LAREDO SPRINGS
(AMENDING)
PRELIMINARY OVERALL DEVELOPMENT PLAN
#427-F

Re: Laredo Springs (Amending) POADP # 427-F

POADP NAME: LAREDO SPRINGS (AMENDING)

Re: Amendment of Laredo Springs POADP #427-E

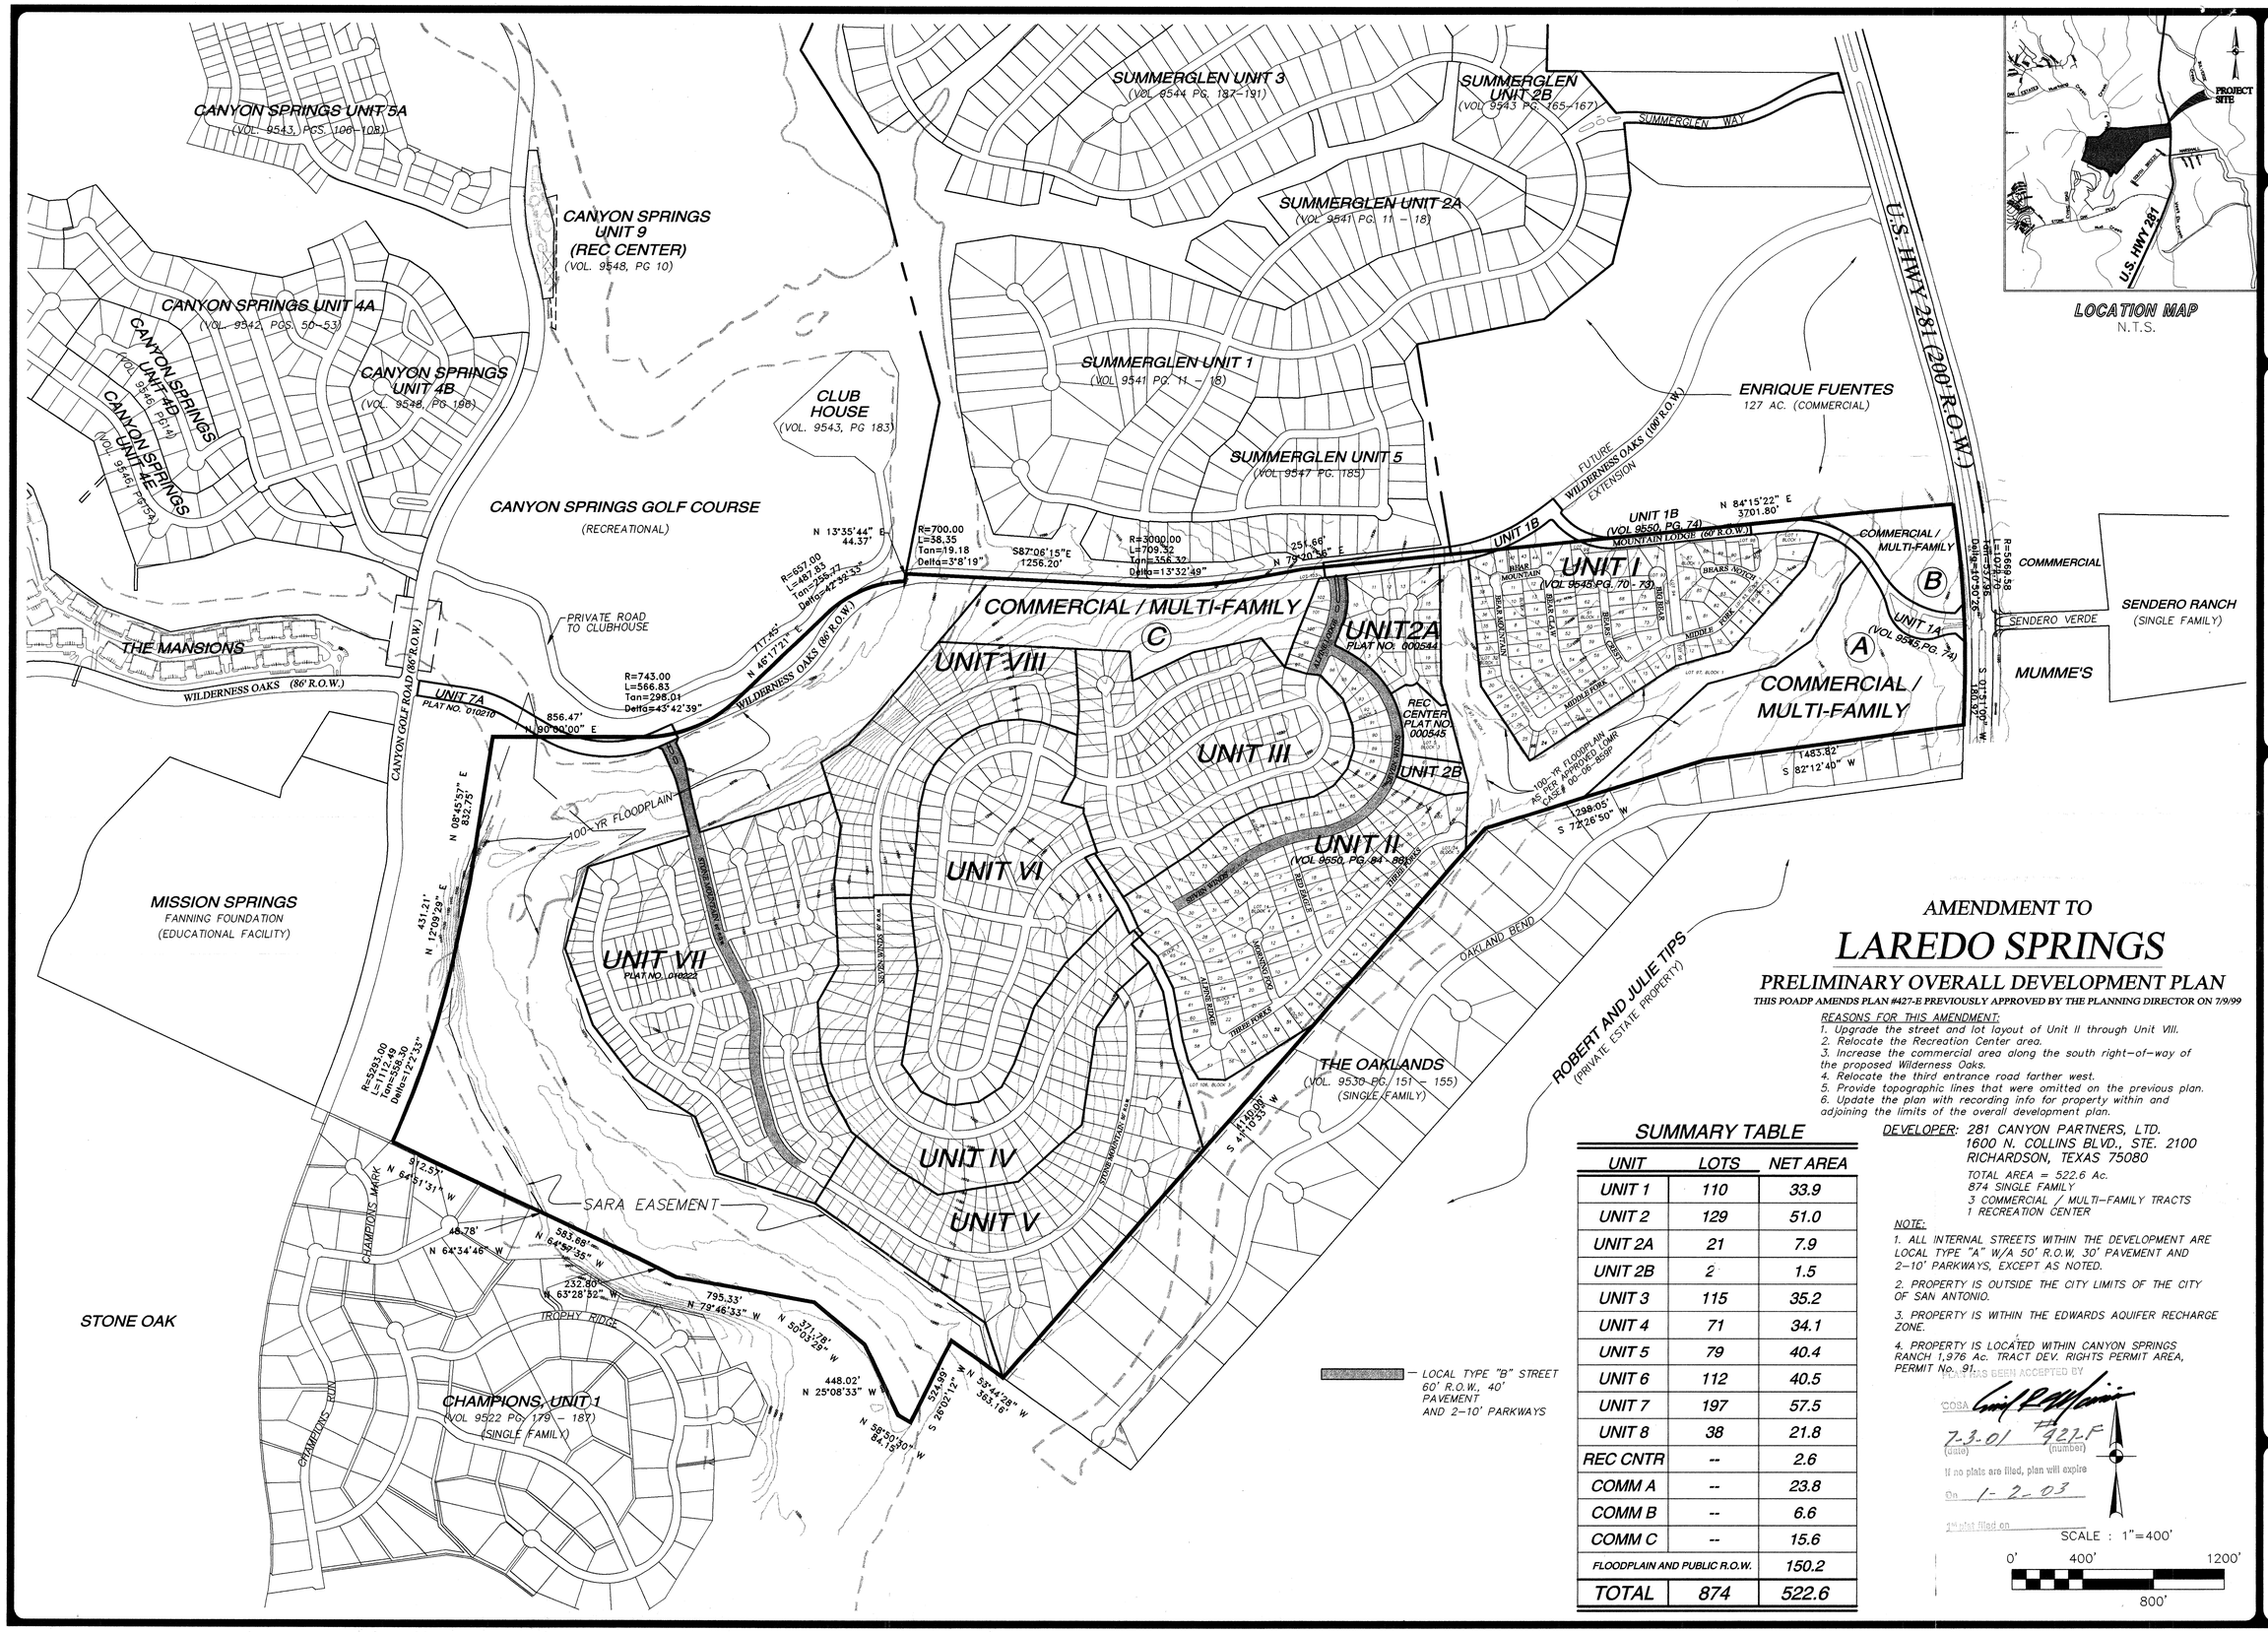
Comments: US 281 IS ON THE MTP AND TXDOT SYSTEM REQUIRING A MIN. OF 110' ROW AND TXDOT RELEASE. WILDERNESS OAKS IS ON THE MTP REQUIRING A MIN. OF 86' ROW. CANYON GOLF RD IS ON THE MTP REQUIRING A MIN. OF 86' ROW.

Comments: US 281 IS ON THE MTP AND TXDOT SYSTEM REQUIRING A MIN OF 110' ROW AND TXDOT RELEASE. WILDERNESS OAKS IS ON THE MTP REQUIRING A MIN 86' ROW. CANYON GOLF RD IS ON THE MTP REQUIRING A MIN OF 86' R.O.W. PROPOSE POADP NEED TO SHOW R.O.W. DIMENSIONS FOR ABOVE MENTIONED R.O.W.

Comments: Location map
Show contiguous POADPs (if any)
review TIA - increased commercial

Comments: REVISE TIA SHOWING DIFFERENCE BETWEEN ORIGINAL & PROPOSED POADP.

Comments: Approval pending on the following comments:
- Evaluate sight distance at intersections noted on red marks.
- Drainage easement will be required to contain 100 year flood plain.

1. Zoning – Location Map is missing
   A location map is now shown at the upper right corner of the plan

2. Major Thoroughfare – show right-of-way width on collector and secondary street and U.S. 281
   All major right-of-ways including U.S. 281 are labeled with corresponding right-of-way width.

3. Traffic Division – need TIA update
   A TIA update study and a Threshold Worksheet have been submitted to Todd Sang (I also met with him a week ago about this concern.)
